**1. Site Plan Administrative Review 2019-08, Wiper Shaker**

# Site Plan Review

Project: Wiper Shaker Storage Building  
6723 E. Railway Commons  
Williamsburg, MI 49690

Request: Administrative Site Plan Review 2019-08

TOPOGRAPHICAL SITE PLAN

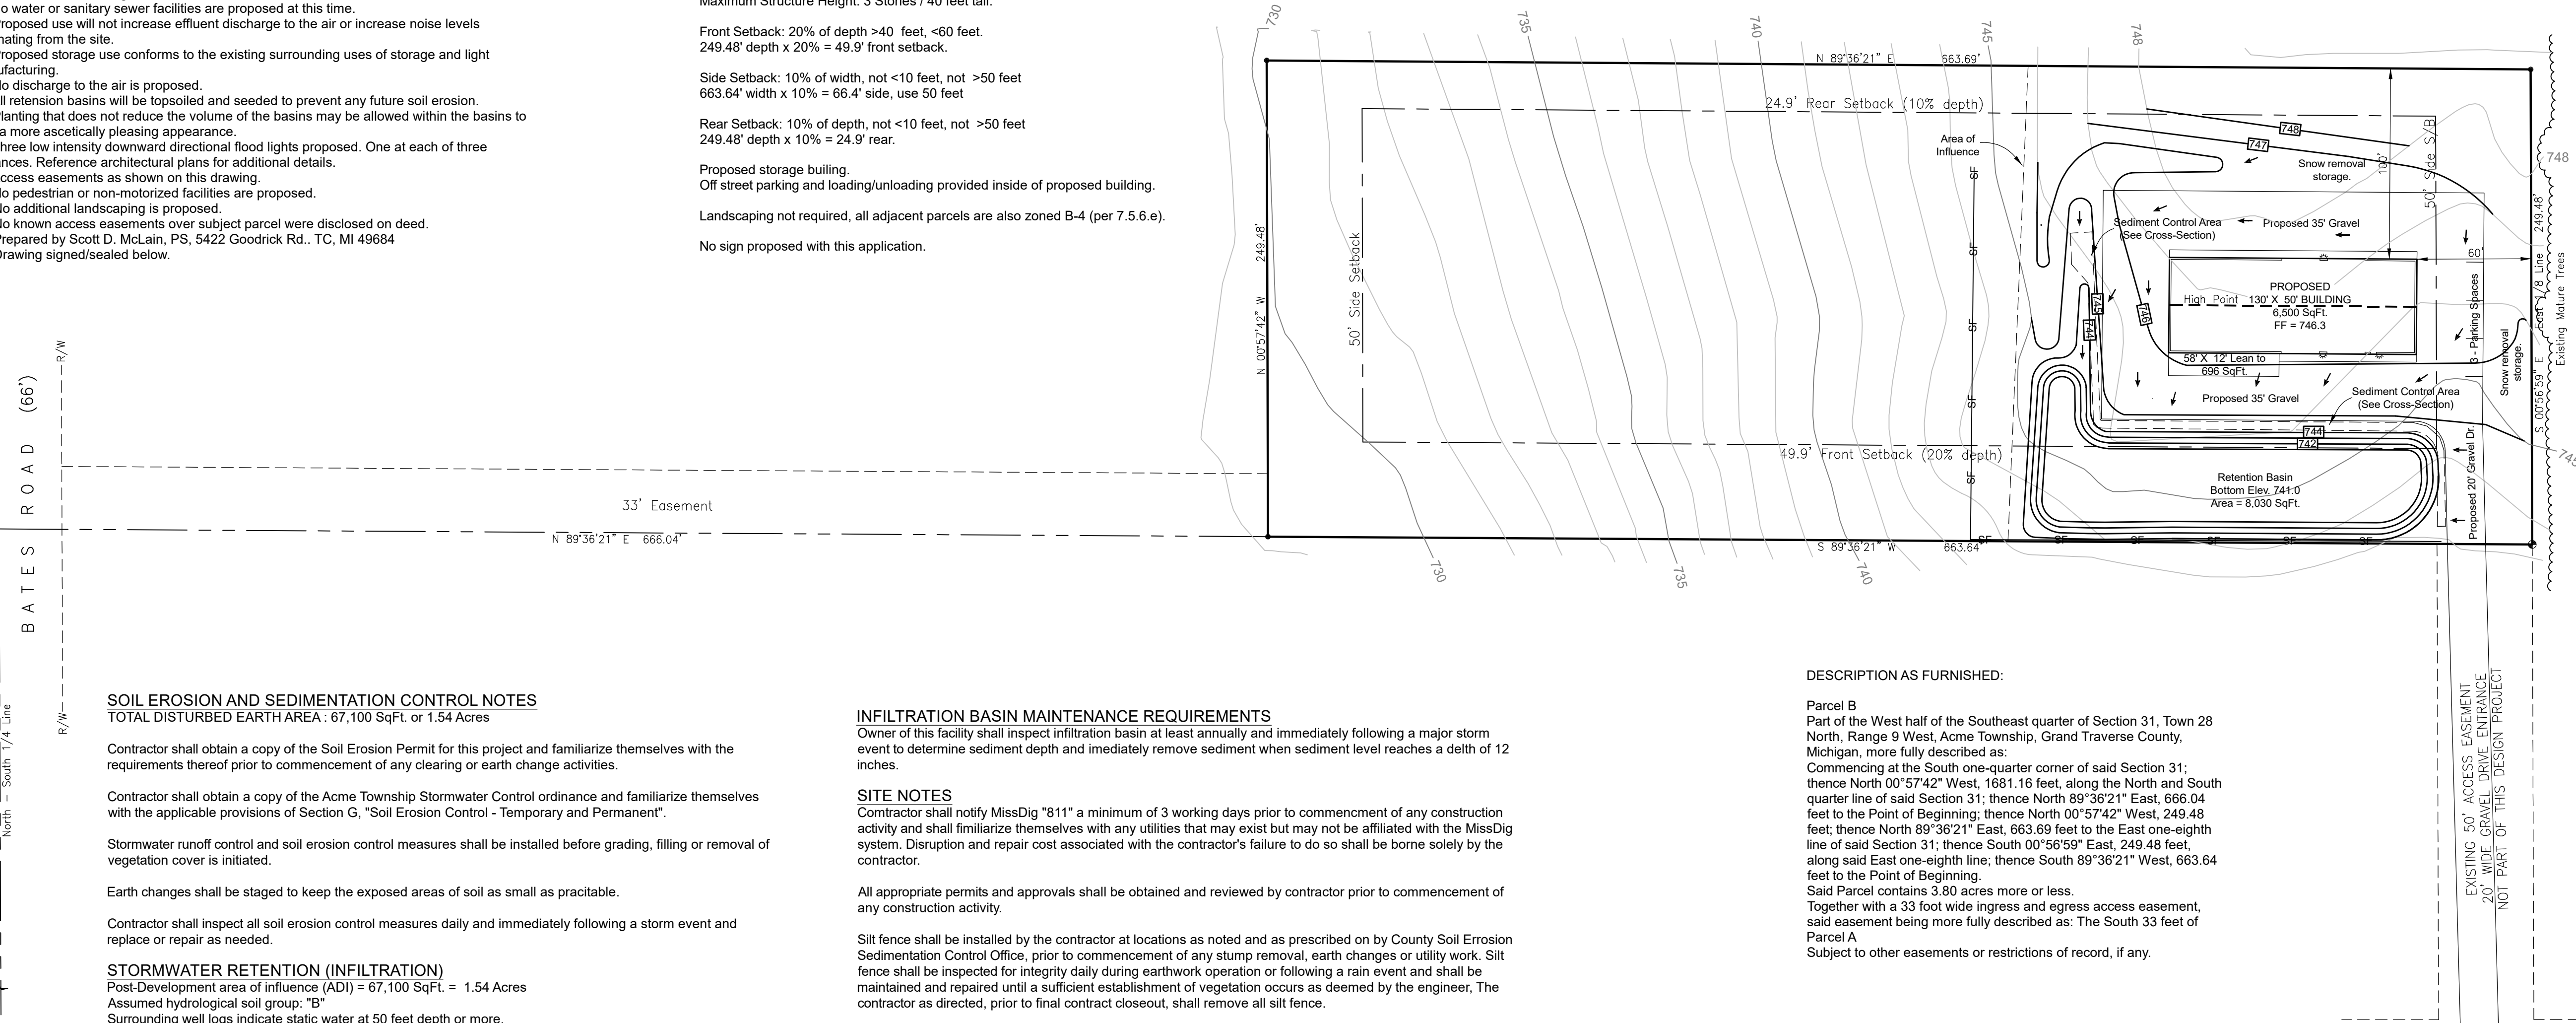
b. That all required information has been provided.	<b>Conditionally Satisfied:</b> Per Application requirements 8.1.4 (3) Does not indicate the number of employees that will access site on a daily basis. (23) The most recent site plan revised 9.16.19 is not signed or sealed.

o. That landscaping, fences or walls may be required when appropriate to meet the objectives of this Ordinance.	<b>Conditionally Satisfied:</b> landscaping not required per 7.5.6 (e) . Snow storage area does not indicate square footage.

Stormwater review is pending. Original plans submitted on August 16, 2019 did not receive a favorable stormwater review.

1. What is the purpose of the proposed lean to on the plan?
2. The number of employees having access to the site on a daily basis needs clarification.
3. The area of snow storage needs to be clarified/square footage.
4. Where is the proposed loading zone entry per section 7.5.5? Loading space is permitted in the rear yard only – an exception of loading in the side yard may be approved the planning commission.

1. Items 1-4 in the summary have been addressed and any necessary revisions made to the plan set – subject to review by the Planning and Zoning Administrator for compliance.
  - 1) What is the purpose of the proposed lean to on the plan?

- 2) The number of employees having access to the site on a daily basis needs clarification.
  - 3) The area of snow storage needs to be clarified/square footage.

- 4) The location of the loading zone entry per section 7.5.5 needs to be clarified. Loading space is permitted in the rear yard only – an exception of loading in the side yard may be approved the planning commission. Must be composed of a hard/dust-free surface.

2. All exterior security lighting shall be limited to shielded, downward facing fixtures located above the entrances and doorways.
3. Before issuing a land use permit:

- a. Submit a set of revised plans in electronic pdf format and a set of full-size prints sealed by a licensed engineer, architect or landscape architect and signed by the Applicant and Planning Commission Chair.

- b. Obtain a valid soil erosion permit.
  - c. Receive a favorable stormwater review from Gosling Czubak.
